**Amendments to the Drawings:**

**REMARKS****I. Status of the Claims:**

The Title of the Invention has been objected to as being non-descriptive. As suggested by the Examiner, Applicants have amended the Title to read as follows: Three-Dimensional CAD Attribute Information Presentation.

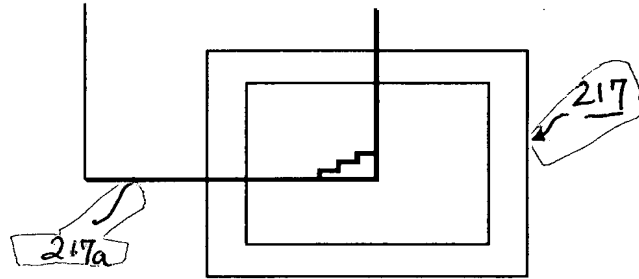
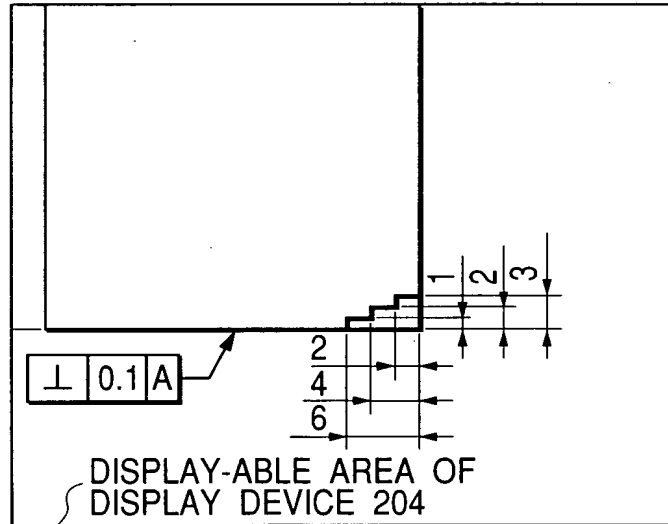
Second, the Office Action indicates that the drawings do not identify a plane 217 and frame 217a described on page 63, lines 14-25 with reference to Figs. 23A-23C. To address the Examiner's concerns, Applicants have amended the drawings to address the above noted matters. Corrected replacement drawing sheets of Figs. 23A-23C with these changes in compliance with 37 C.F.R. 1.121(d) are provided for approval and entry by the Examiner.

The attached sheet of drawing include changes to Figs. 23A-C. This sheet, which include Figs. 23A-C, replace the original sheets including Figs. 23A-C. A marked up sheet of the figures is also provided for the Examiner's reference.
